**FINDINGS AND RECOMMENDATION
OFFICE OF PLANNING AND ZONING
ANNE ARUNDEL COUNTY, MARYLAND**

CASE NUMBER: 2025-0075-V

The applicants are requesting a variance to allow a driveway with disturbance to slopes of 15% or greater on property located at 641 Lakeland Drive South in Severna Park.

PROPOSED CONDITIONS

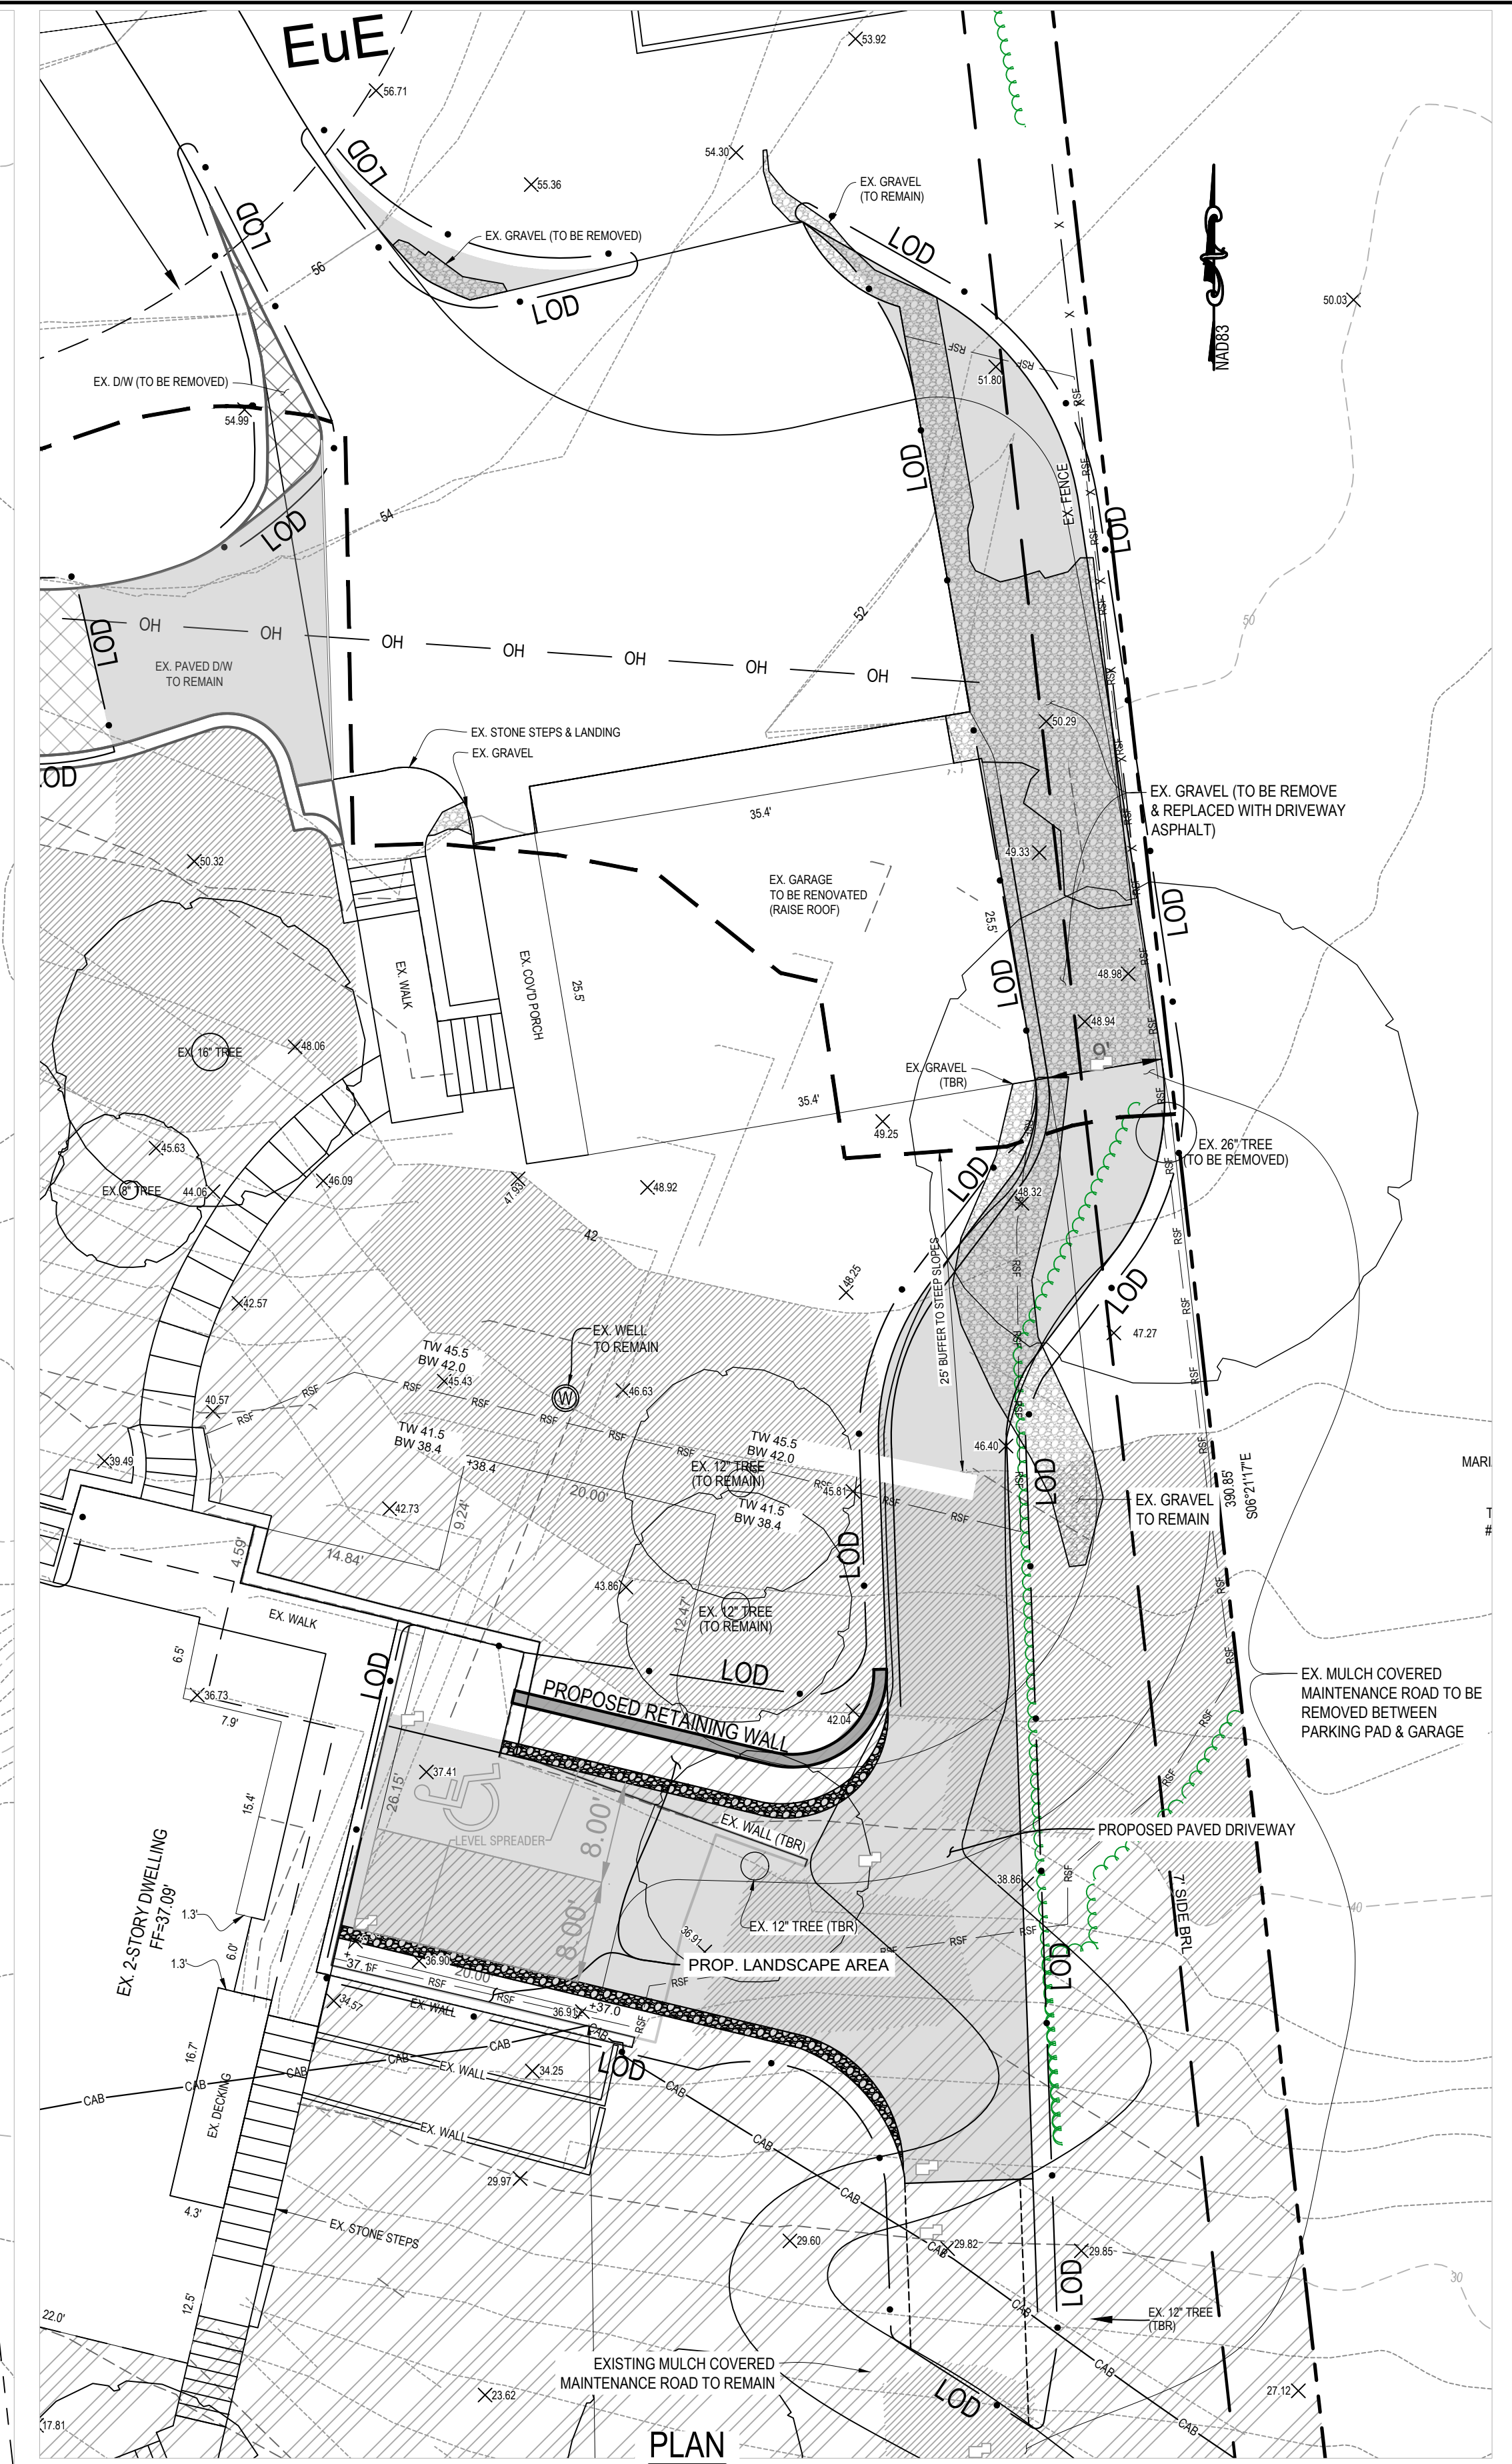
The existing critical area lot coverage of the site is noted as 11,068 square feet (and also 10,877sqft on sheet 2).

The site plan should be revised to clarify the lot coverage summaries, as some of the figures do not correspond.
